Docket No. 50-346

DAVIS-BESSE 1 SER INPUT

Plant Name: Davis-Besse 1
Docket No.: 50-346
Milestone No.: 01-24
Licensing Stage: OL
Responsible Branch and Project Manager: LWR 2-3, L. Engle
Technical Review Branch Involved: Reactor Systems Branch
Description of Review: SER Input
Requested Completion Date: August 15, 1975
Review Status: Complete

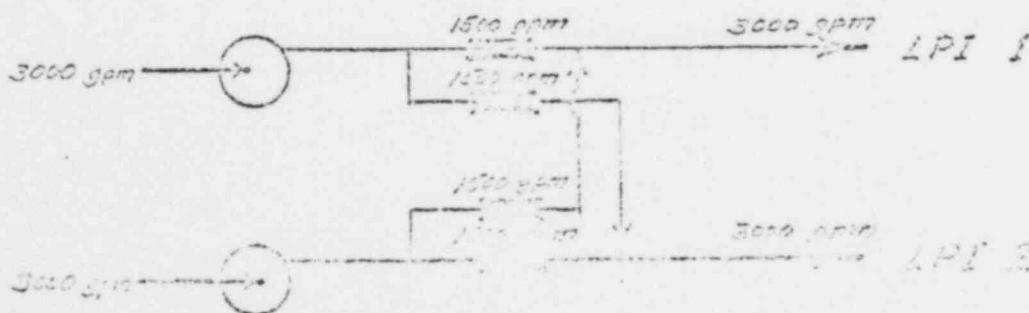
the reactor building is provided so that if a single failure causes the loss of LPI flow in one path, part of the flow from the active LPI path can be injected into the reactor vessel through the piping associated with the inactive path. The cross-connect is also intended to assure abundant long-term cooling flow to the core in the event of a core flooding line break in addition to this single active failure. We have required that this cross-connect be modified to incorporate a passive network design similar to that adopted on such plants as Arkansas Nuclear One Unit 1 and North Anna 3 and 4 (plus all 205-Fuel Assembly plants). This preferred method consists of crossover lines which contain no motor-operated valves. Instead, this crossover network utilizes the flow-limiting characteristic of a cavitating venturi to provide an automatic split in ECC water between the two LPI trains. The following simplified diagram illustrates this principle:

The obvious advantage of the latter method is that it does not rely on operator action to be initiated and it is less prone to active component failures.

in the crossover lines between the HPI pump suction and the LPI pump discharge lines. Operator actions required to mitigate the consequences should be minimized and ECCS component reliability kept at a high level. Therefore, the normally closed valves in each of the two crossover lines should be remote motor-operated valves with position indication and controls in the control room.

2. For a break in a core flooding line, a single active component failure could degrade available ECCS to the point of compromising the abundant core cooling requirement of General Design Criterion 35. To meet this criterion, Toledo Edison Company has installed a crossover line between each LPI train which is manually actuated from the control room. To further minimize operator actions and maximize ECCS component reliability, we will require a passive crossover network between the two LPI trains.
